1 Products affected

2 Type of change

Change of material

Product Change Notification					PCN MGA series change of blister belt		
owner	creation date	release date	released by	change order no	rev	page	D10-042-010
elmigeth	08.01.2021	08.01.2021	haeckima	2018992	B	1 of 2

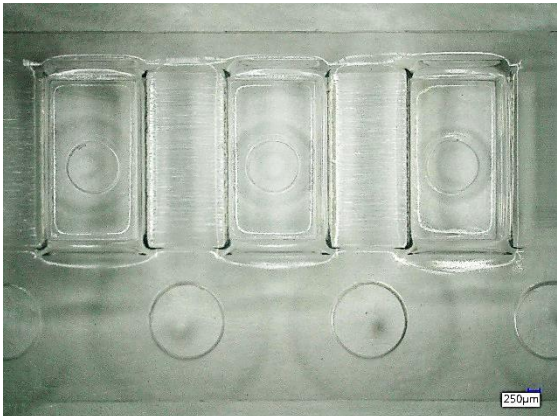
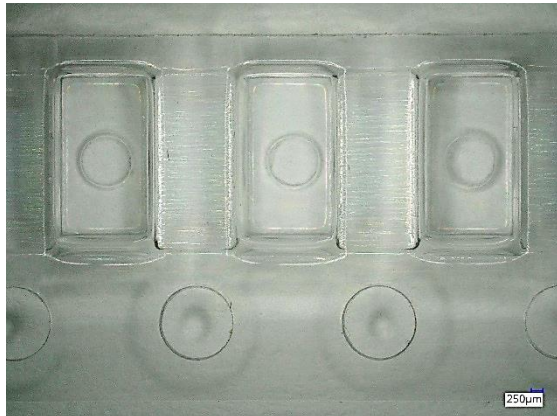
Old product description	New product description
H-PVC transparent, shiny, antistatic	PET GAG, volume antistatic, transparent
Old product picture	New product picture

The change is done due to a material change at supplier side.

The change takes effect in ww 03/2021. (Date code 2103 or higher on label) The stock produced prior to the change will be shipped until depleted.

Form	No	
Fit	No	
Function	No	
Manufacturing	No	
Label	No	
Packaging	Yes	No action necessary, as we expect no functional changes of packaging.
